MMO Reference: DCO/2022/00012
Planning Inspectorate Reference: TR030008

Planning Act 2008 - Immingham Green Energy Terminal Development Consent Order Deadline 1 Submission

This document comprises the MMO comments in respect of the DCO Application submitted in response to Deadline 1.

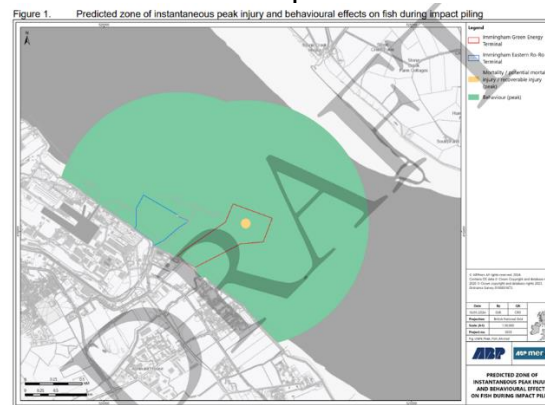
MMO comment: The results presented in SEL for the cumulative SEL effects zones for fish (Fig 2 above) seem to be the result of overlapping of circular effect zones centred at the location of the two piling rigs, with the radii of these zones calculated for each of the two piling locations.

As noted in section 1.6.11 of Appendix 9B (the original noise assessment), in order to determine the resultant total sound pressure level (SPL) of multiple sources, the SPLs need to be added logarithmically, according to the formula given in 1.6.11. Thus, in principle, the effect zones need to be determined by calculating the field SEL from each of the two rigs, adding them up at each field location, and then drawing the effect zone contours for the relevant thresholds on the resulting SEL map. The resulting effect zones will be larger than the simple overlap of the effect zones that could be calculated separately for each of the two locations, due to the summation effect of SELs. In practice, for the scenario illustrated in Figure 2, the effect of this SEL summation is probably minimal, since the mortality and recoverably injury zones are quite small compared to the distance between the two rigs, while for the TTS, the overall effect zone is likely dictated by the largest of the two effect zones.

Figure 3 and Figure 4 at the end of this document present the minimum and maximum separation distances between the piling rigs at the jetty approach and jetty. These are illustrative only and based on the current understanding of the construction operations.
